CODE COMPLIANCE CERTIFICATE

Street Address	148 FIELD WAY, WAIKANAE BEACH
Valuation No.	1491075868
Legal Description	Lot 57 DP 333393
Year Constructed	
Current Use	
Proposal	New Dwelling

B.C 055239

MIKE BURGE BUILDERS
LOT 57 FIELDWAY, WAIKANAE BEACH.

SITE AND DRAINAGE PLAN
SCALE 1:100

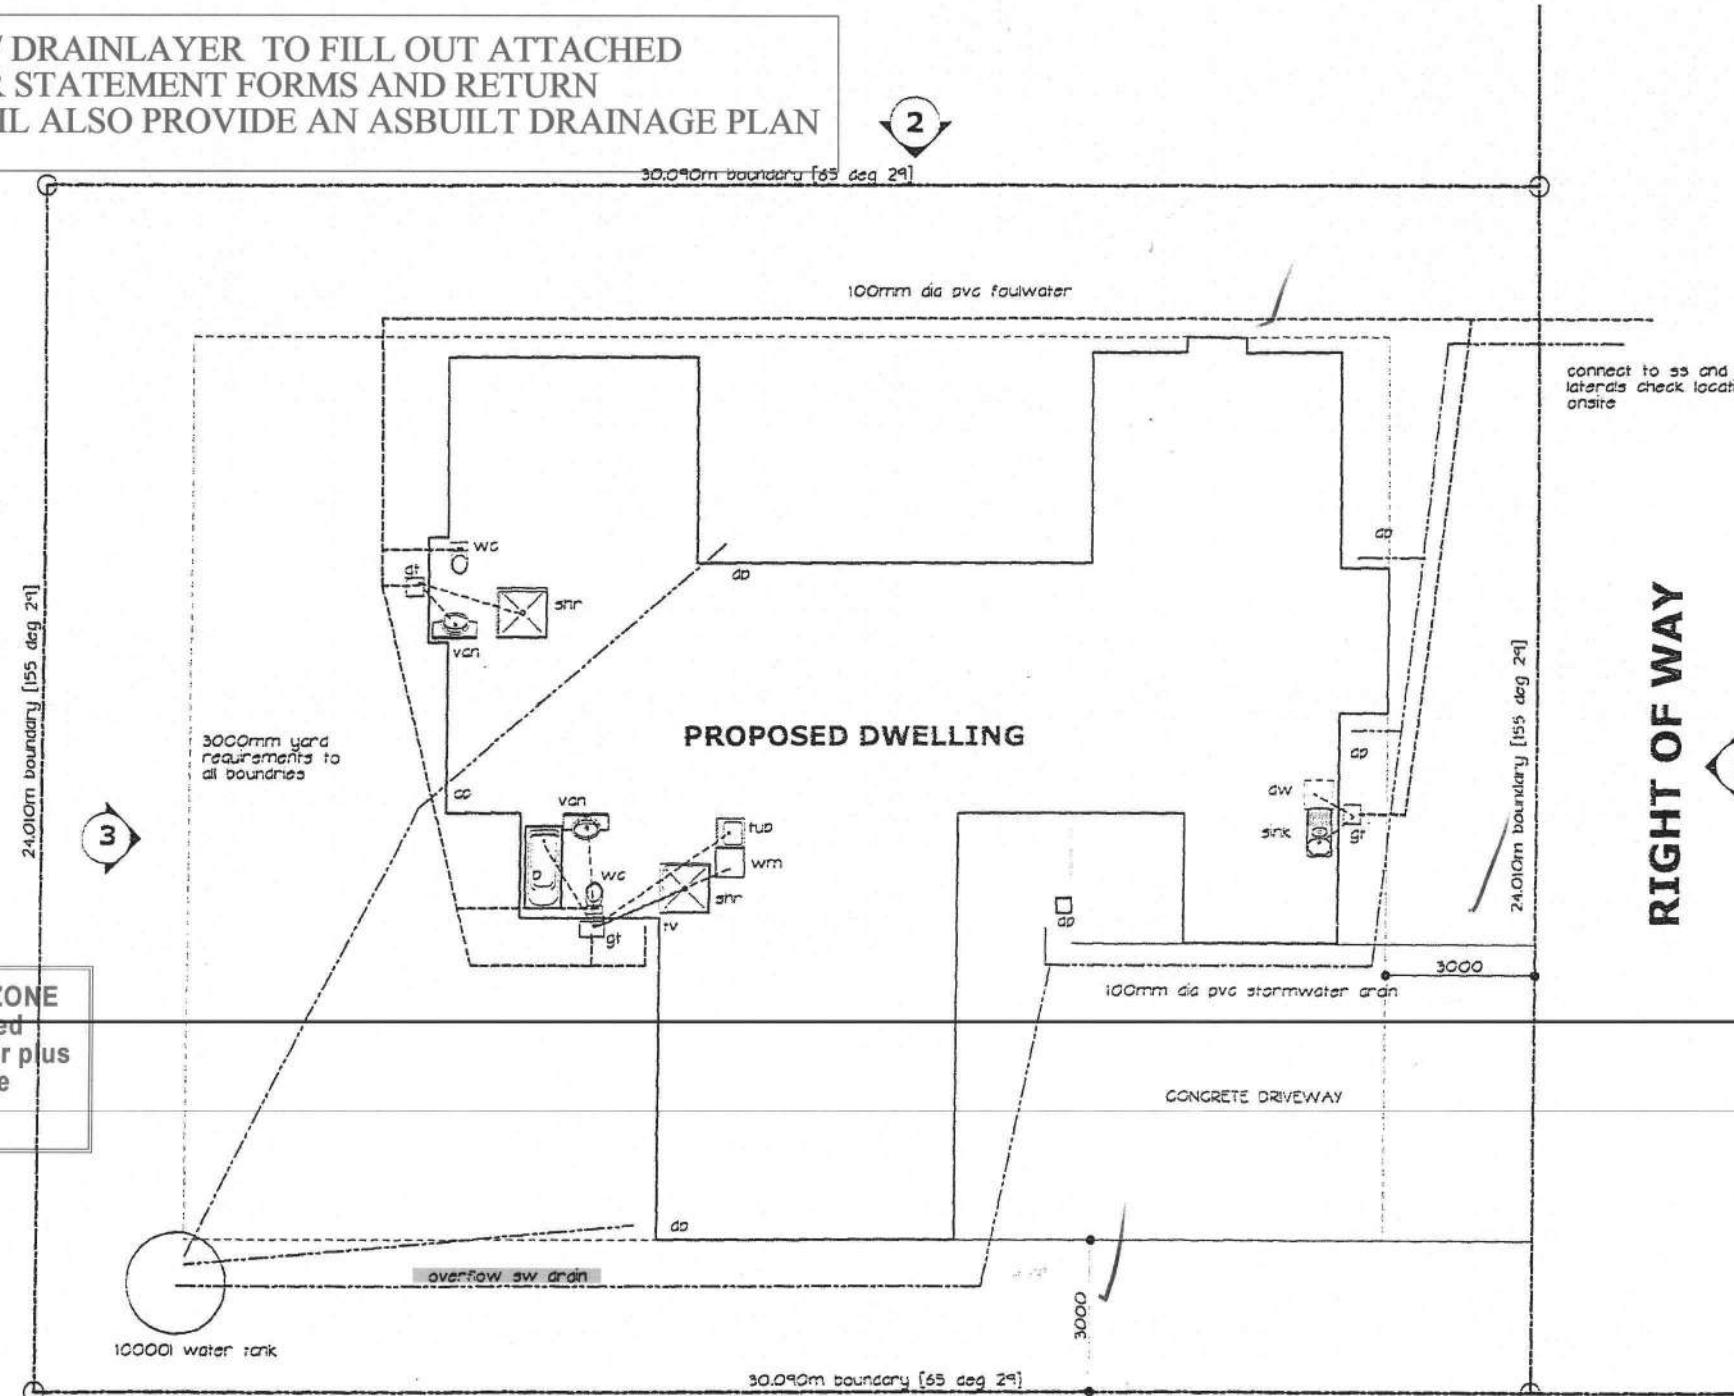
Plumbing to be installed as shown on the approved plan. If a deviation is made an amended plan is to be provided at the time of the preslab plumbing inspection.

PLUMBER / DRAINLAYER TO FILL OUT ATTACHED PRODUCER STATEMENT FORMS AND RETURN TO COUNCIL ALSO PROVIDE AN ASBUILT DRAINAGE PLAN

BUILDER TO ENSURE THAT PROPOSED FOUNDATION HEIGHT WILL ALLOW A SATISFACTORY DRAINAGE CONNECTION TO THE SEWER MAIN

ELEVATION ONE

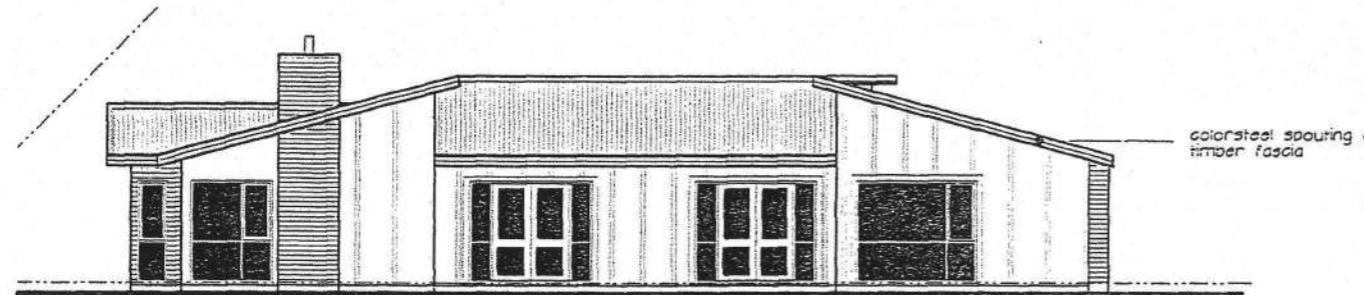
fit flashings to horiz joints

A = SCALA TEST LOCATIONS

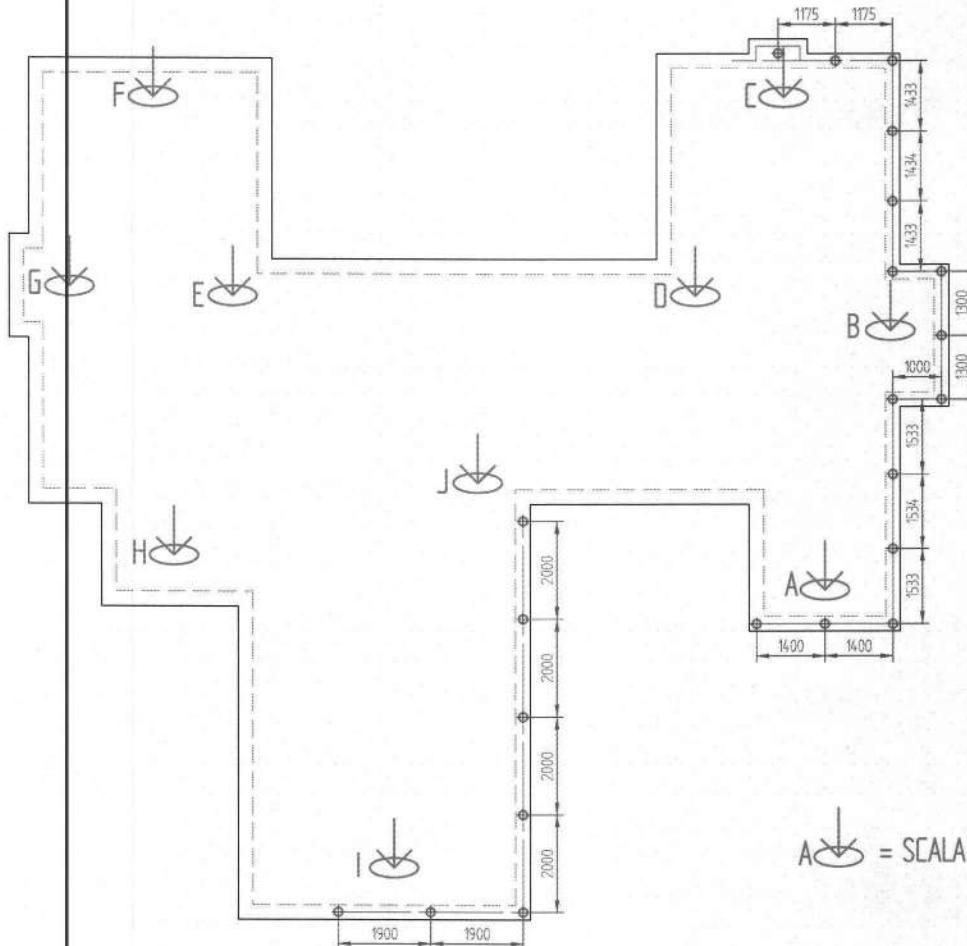
Standard foundations, with the addition of drilled and cast in situ concrete piles of specified depth in areas indentified as less than 100kpa over 1m below EGL at the time of foundation testing (engineers direction). *See attached plan

SITE AND DRAINAGE PLAN
SCALE 1:100

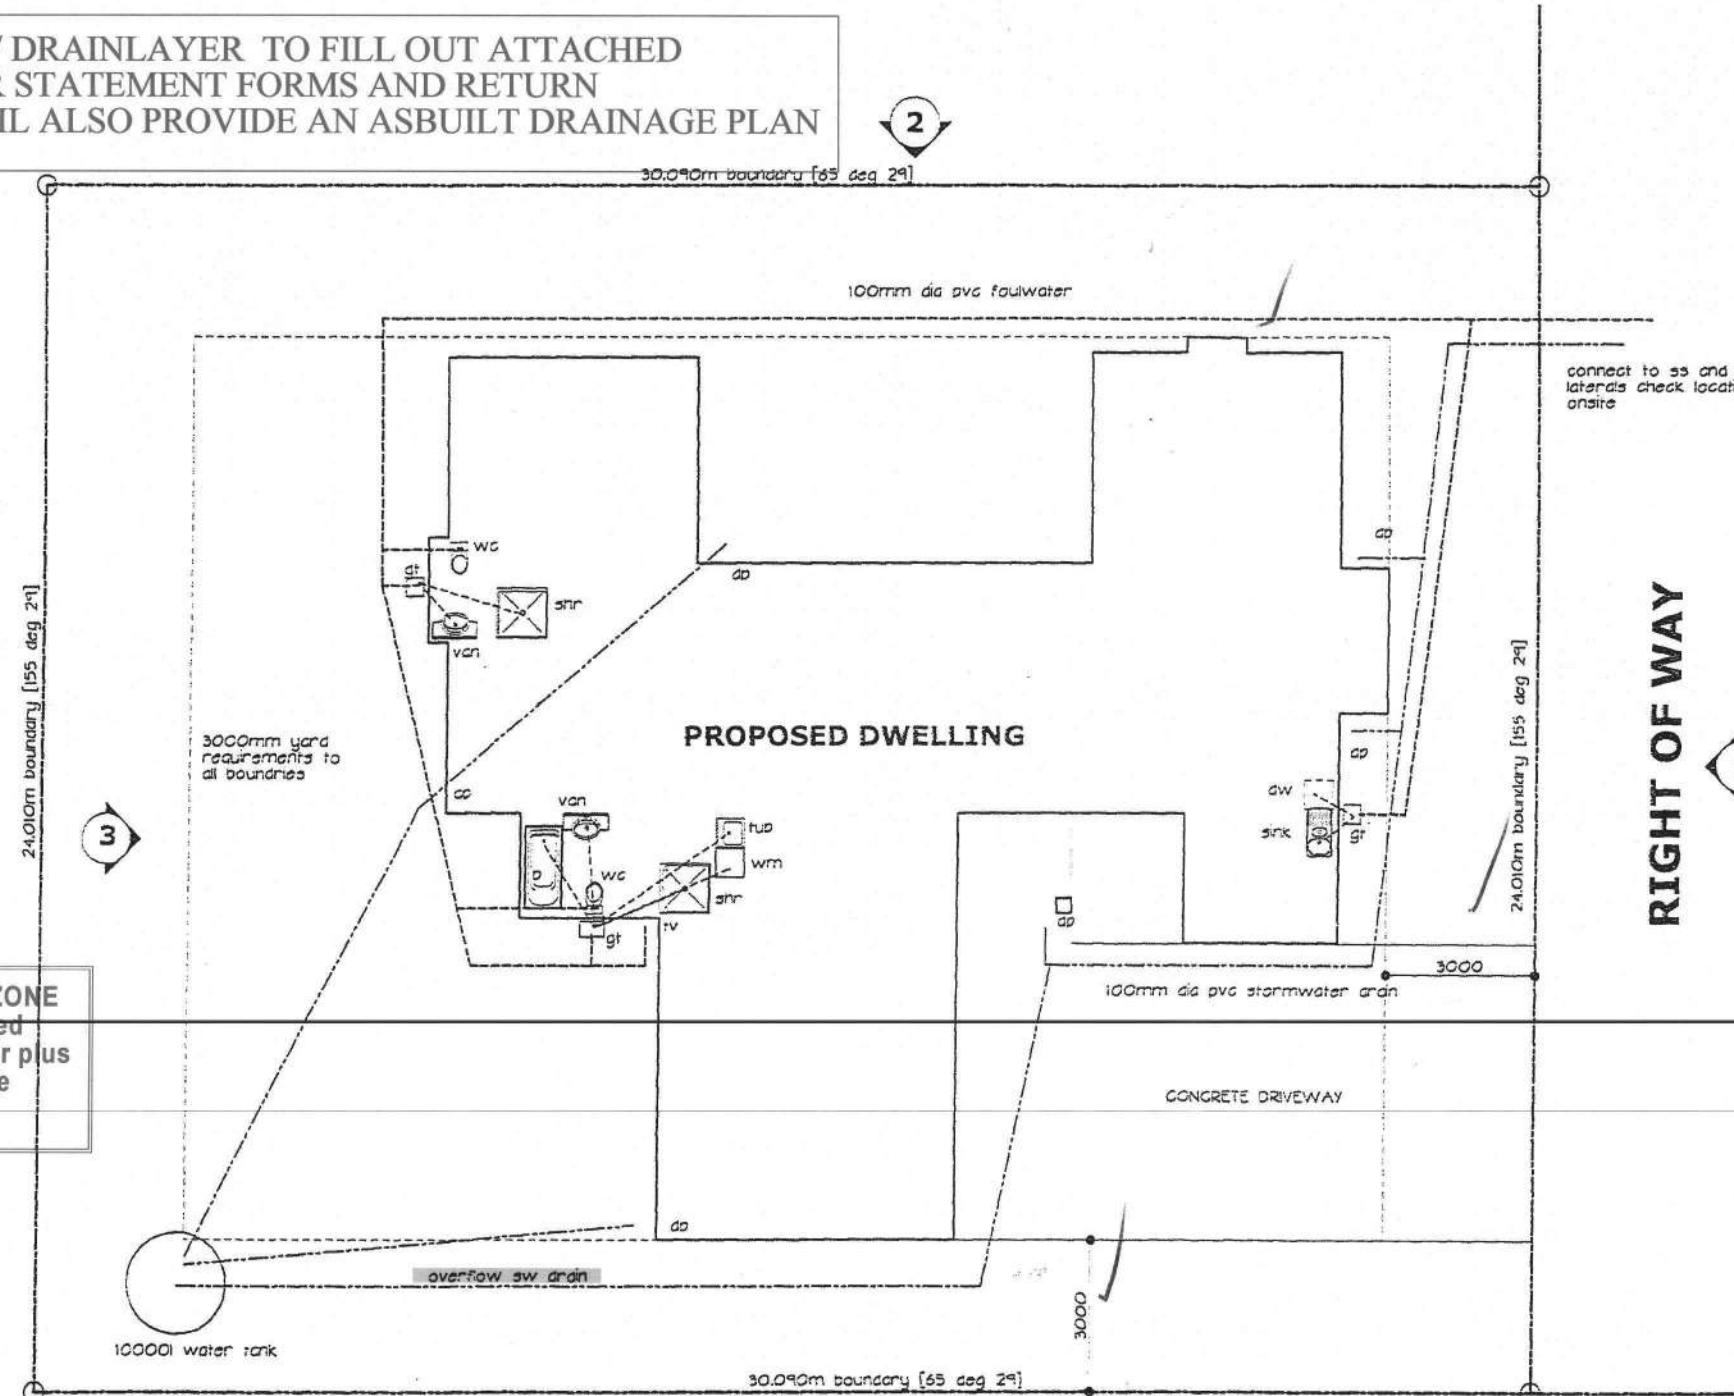
Plumbing to be installed as shown on the approved plan. If a deviation is made an amended plan is to be provided at the time of the preslab plumbing inspection.

PLUMBER / DRAINLAYER TO FILL OUT ATTACHED PRODUCER STATEMENT FORMS AND RETURN TO COUNCIL ALSO PROVIDE AN ASBUILT DRAINAGE PLAN
